Subject: **Automatic Battery Cutoff Switch (BCS), Malfunctioning  
Resulting in Battery Discharge**

Number: **04-05**

Model(s): **Touareg 5.0L V10 TDI (Eng. code BKW) 2004**

Date: **July 1, 2004**

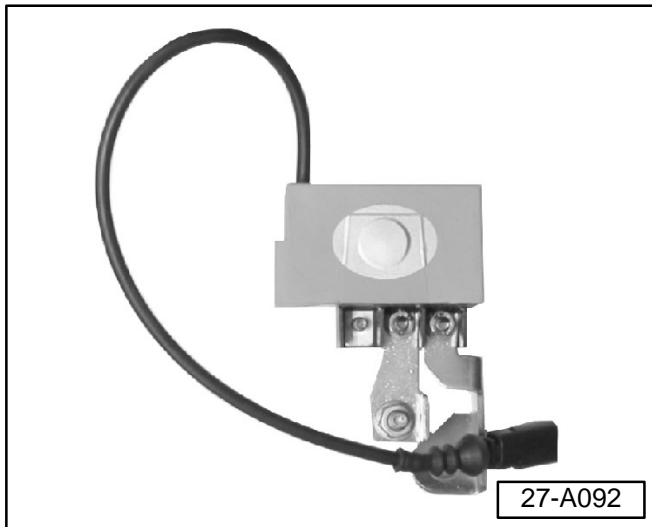
◀ On some Touareg V10 TDI vehicles, an Automatic Battery Cutoff switch (BCS) is used during the transportation cycle and according to Technical Bulletin Group 00 number 04-02 dated April 6, 2004 should be removed within 48 hours from delivery to the Customer.

The BCS is Orange in color with Part No. 7L0943383 or 7L0943383A.

- Verify Orange color Automatic Battery Cutoff Switch (BCS) is present in the vehicle.
- Immediately remove the Automatic Battery Cutoff Switch (BCS) using procedures described in Technical Bulletin Group 00 number 04-02 dated April 6, 2004. DO NOT wait until 48 hours prior to delivery to the Customer.
